City of Portland, Oregon
Bureau of Development Services
Land Use Services
FROM CONCEPT TO CONSTRUCTION

NOTICE OF A TYPE Ix DECISION ON A PROPOSAL IN YOUR NEIGHBORHOOD

CASE FILE NUMBER: LU 19-109575 LDP

Proposal: The applicant is proposing to divide this currently vacant 5,557 s.f. corner property into three (3) parcels. The applicant is utilizing the corner lot alternative development option (33.110.240.E) to create attached housing lots for Parcels 1 and 2, which allows an extra unit of density. Parcel 1 will be 1,660 s.f. in area and Parcel 2 will be 1,662 s.f. in area. Parcel 3 will be 1,963 s.f. in area and will be developed with a detached single-family house. The applicant's preliminary site & utility plan shows how services (sanitary, stormwater, and water) will be provided for each lot.

CASE NO. 19-101575
 EXHIBIT C.1

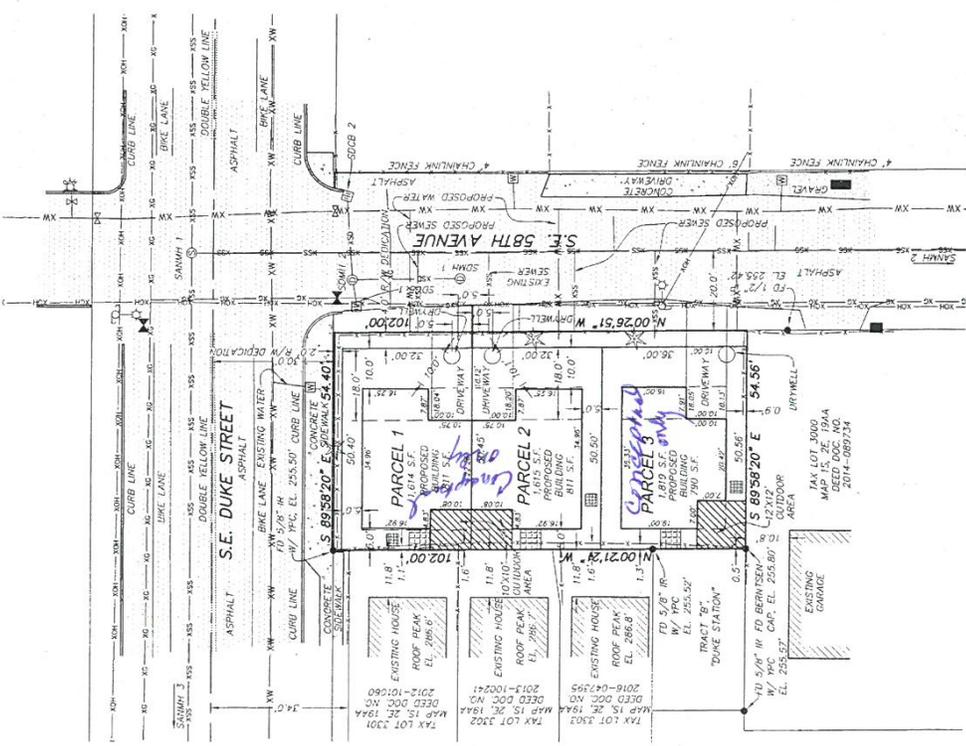
The applicant's site utility plan (Exhibit C.1) shows new individual water service connections for each lot within the frontage of each parcel from SE 58th Avenue. Water Bureau provided the following comments:

- Parcel 1 has a 5/8-inch metered domestic service. If the service is not used for the new development, it must be removed at the time the new services are installed. If the service is used for the new development, the meter size will be reviewed for adequacy. If found to be inadequate the applicant will be responsible for all fees to upsize the service.
- The existing 2-inch water main in SE 58th Avenue is at capacity. To serve Parcels 2 and 3 the water main must be upsized at the applicant's expense. The applicant is responsible to upsize the main to the point of connection or 5-ft inside of Parcel 3, whichever is greater.

- The applicant's site utility plan (Exhibit C.1) shows Parcels 1, 2 and 3 will receive sanitary service from the 8-inch public sanitary sewer in SE 58th Avenue.

BES notes City records and the submitted site plan indicate that there may be an existing lateral within the frontage of Parcel 3. If this is the case, this lateral may be available for use on Parcel 3. If it is not within the frontage of Parcel 3, the new development must be served by a new connection to SE 58th Avenue within the frontage of Parcel 3. Parcels 1 and 2 will be served by a new connection to the sanitary sewer in SE 58th Avenue within its frontage. BES finds the applicant's proposal for sanitary service acceptable for reviewing the preliminary land division application against the sanitary sewer disposal standard and approval criterion.

BES noted the following in regards to Private Property Stormwater Management Infiltration Facility Setback Requirements: Note that infiltration facilities must be set back 5 feet from property lines and 10 feet from structures, as measured to the low point of vegetated facilities, the middle of drywells, and the edge of soakage trenches. Other required minimum setback distances that should be taken into account are summarized in Table 2-1 of the SWMM. BES will enforce these setbacks unless an alternative is allowed per the [BDS Drywell Location Code Guide](#) or is approved through the [BDS plumbing code appeal process](#). Note that the BDS code guide may allow drywells to be located closer than 5 feet from a property line if the property line is adjacent to a right of way (including streets, alleys and public or private pedestrian tracts). The code guide also includes criteria for reducing drywell setbacks to buildings.

The applicant's site utility plan shows the drywell location less than 5-ft. to the property line adjacent to the right-of-way (SE 58th Avenue).

The applicant provided a conceptual street tree planting plan (Exhibit C.1) showing future street trees being planted along SE Duke and along SE 58th Avenue. This plan meets the requirements of 11.50.060 for street tree planting.

SE Duke Street: The existing street tree (cherry) is being proposed to be removed due to the location of the future driveways. Removal of the street tree will require mitigation to occur at the time of development.

1. The applicant shall meet the street dedication requirements of the City Engineer for SE Duke Street and SE 58th Avenue. The required right-of-way dedication must be shown on the final plat.

1. The applicant shall meet the requirements of the City Engineer for right of way improvements along the site's street frontage. The applicant shall complete the process for the Public Works Permit (19-153892 WT/TH0872) and provide final plans and financial assurances to the satisfaction of the Portland Bureau of Transportation and the Bureau of Environmental Services for required street frontage improvements.

2. The applicant shall meet the requirements of the Water Bureau for providing financial payment to upgrade in size of the water main in SE 58th Avenue. This condition shall be met to the satisfaction of the Water Bureau.

3. The applicant must pay into the City Tree Preservation and Planting Fund [Street Trees – Fee in Lieu of Planting and Establishment (per inch)] the amount equivalent to 1.5 inches of trees. Payment must be made to the Bureau of Development Services, who administers the fund for the Parks Bureau.
